[Docket No. FAA-2023-0668; Project Identifier AD-2023-00199-R; Amendment 39-22453; AD 2023-11-07]

Airworthiness Directives; Various Helicopters

Final rule; request for comments.

Figure 1 to paragraph (g)(1)(i)— *Fundamental Effective Isotropic PSD at Outside Interface of Rotorcraft Antenna*

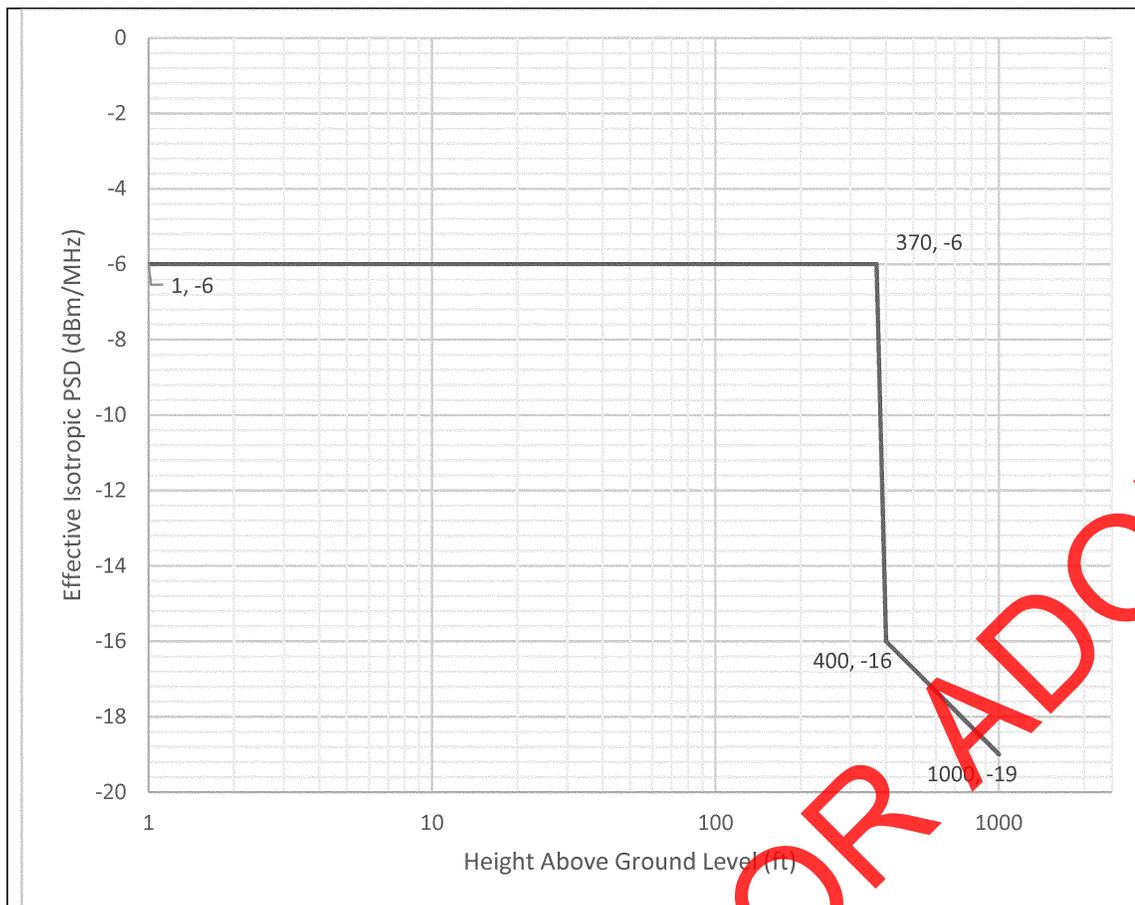
Comment summary: HAI, Sikorsky, and Thales requested that the FAA revise the proposed AD to include the frequency range to which the PSD tolerance curve thresholds apply, a new figure indicating the spurious tolerance similar to the figure with the PSD tolerance curve, and a specification of the altitude dependence for spurious tolerance.

Comment summary: Thales and Sikorsky requested the FAA clarify several aspects of the PSD curve in figure 1 to paragraph (g)(1) of the proposed AD: whether no elevation mask is taken into account at and below 350 feet above ground level (AGL); at which base station emission power the PSD curve corresponds (62 dBm/MHz or 65 dBm/MHz); and whether the radio altimeter performance criteria in the curve explicitly covers any 5G emitter station up to 65dBm/MHz in the applicable 3.7–3.98 GHz band, for the foreseeable future. Sikorsky requested that the FAA revise the proposed AD to include a PSD curve that reflects the reduced EIRP levels for helicopters operating at the 188 priority airports (5G CMAs) with reduced power levels.

Comment summary: Sikorsky requested the FAA revise the PSD curve in figure 1 to paragraph (g)(1) of the proposed AD to change the height above ground at -6 dBm/MHz from 270 feet to 370 feet, and at -16 dBm/MHz from 300 feet to 400 feet. Sikorsky stated its request was based on several factors, including the minimum safe obstacle avoidance distance and the typical decision height used for radio altimeter critical operations associated with missed approach points (MAPs) during point in space (PINS) approaches. Sikorsky further stated that radio altimeters are not operationally used above 1000 feet, and therefore there is little value for any PSD restrictions above 1000 feet operationally.

FAA response: The FAA agrees and has added the frequency range to the PSD tolerance curve. Additionally, as explained previously under “Actions since the NPRM Was Issued,” the FAA has replaced the proposed fixed emission level with a spurious PSD tolerance curve.

FAA response: The notch in the PSD curve does not mean that no elevation mask is taken into account below 350 feet AGL. The elevation mask is taken into consideration below 350 feet AGL and is a fundamental consideration in how the PSD curve was established. The PSD curve was calibrated to cover 5G C-Band emitter stations up to 65 dBm/MHz in the applicable 3.7–3.98 GHz band.

The FAA disagrees with revising the AD to include a PSD curve for helicopters operating at airports with reduced power levels. The radio altimeter tolerant rotorcraft PSD curve was established to provide safe operation anywhere in the contiguous U.S. regardless of whether a helicopter is operating at a 5G CMA.

FAA response: The FAA assumed an emitter base station height of 350 feet based on consensus reached in rotorcraft industry group meetings. Additionally, FAA analysis of existing emitter base station height data shows that, while higher emitters do exist, they are infrequently adjacent to helipads. Second, the FAA assumed the rotorcraft was no closer than 50 feet above and 75 feet laterally from the emitter. The vertical distance was based on pilot feedback and the lateral distance was based on common lateral separation from the main rotor tip recommendations of 2 main rotor diameters from the tip of the rotor, selecting a 30 foot rotor as the smallest rotor in this class of aircraft with the antenna under the main rotor mast. An operator of an individual model rotorcraft with a larger rotor diameter may request approval of an AMOC to the AD on the basis of separation distance. Third, the FAA assumed that the emitter was active at the full rural power level of 65 dBm/MHz allowed in FCC Report and Order FCC 20–22.[2] The FAA then evaluated the resulting curve against data from radio altimeters and found it to be achievable with current technology using filters that have been developed. Based on data from existing emitters, if the height reduction from 370 feet to 270 feet, as requested by the commenter, were adopted, it would result in many more landing scenarios unprotected from

interference because emitters on towers at about 250 feet as opposed to the accepted assumption of 350 feet are much more common. For this reason, the FAA did not adopt this request.

The FAA has re-evaluated the need for PSD performance requirements above 1000 feet and agrees with the reasons provided by the commenter. The PSD curves specified in this AD have been changed accordingly.

Figure 2 to paragraph (g)(1)(ii): *Spurious Effective Isotropic PSD at Outside Interface of Rotorcraft Antenna*

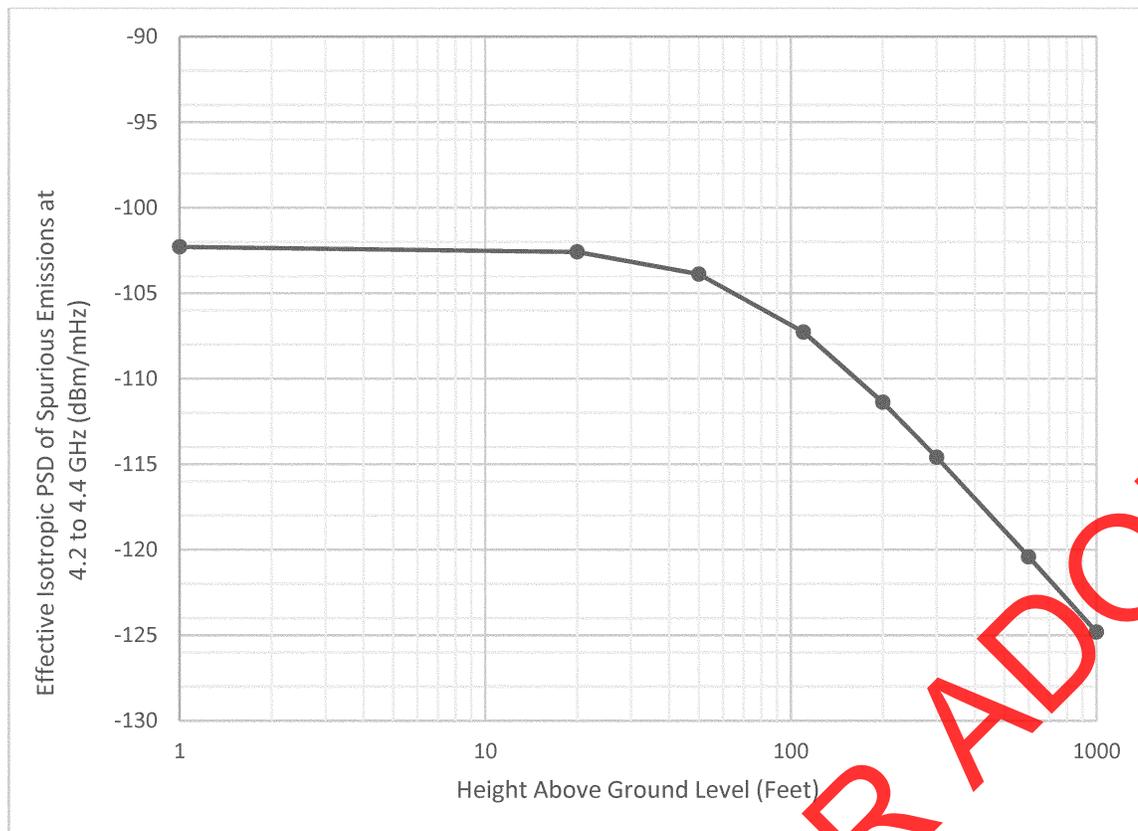
Since the FAA issued the NPRM, the FAA determined that the spurious emission level as proposed in the NPRM would not necessarily address the unsafe condition from both indoor and outdoor emitters. Additionally, commenters of the NPRM requested the FAA replace the proposed fixed aggregate spurious emission level with a spurious PSD tolerance curve.

The FAA analyzed multiple scenarios to determine the worst case spurious emissions a rotorcraft could be exposed to from either indoor or outdoor 5G C-band base stations. The constraining scenario is a rotorcraft operation on a building or elevated platform with a nearby in-building 5G emitter. Figure 2 of paragraph (g)(1)(ii) of this AD is derived by assuming that the rotorcraft is at least 75 ft laterally from the in-building emitter with conducted spurious emissions of -30 dBm/MHz. No building exit losses are accounted for in this curve.

In this final rule, the FAA replaced the proposed fixed aggregate spurious emission level of -42 dBm/MHz (conducted) with a spurious PSD tolerance curve for 5G C-Band interference from a single base station. This form of the requirement is consistent with the transport and commuter category airplane requirement. Similarly, it does not include an aggregation factor or any base station or aircraft antenna gain factors. The spurious PSD tolerance curve is based on a different spurious emission level than what the FAA proposed in the NPRM (-30 dBm/MHz conducted for a single indoor base station instead of -48 dBm/MHz conducted for a single outdoor base station and an aggregation factor of 6 dB which yielded an effective aggregate level of -42 dBm/MHz).

As a result, the FAA is requesting comments on the spurious PSD tolerance curve in figure 2 to paragraph (g)(1)(ii) of this AD.

The FAA invites you to send any written data, views, or arguments about the spurious emissions PSD tolerance curve as specified in figure 2 to paragraph (g)(1)(ii) of this final rule. Send your comments to an address listed under **ADDRESSES**. Include “Docket No. FAA-2023-0668 and Project Identifier AD-2023-00199-T” at the beginning of your comments. The most helpful comments reference a specific portion of the figure, explain the reason for any recommended change, and include supporting data. The FAA will consider all comments received by the closing date and may amend this final rule because of those comments.
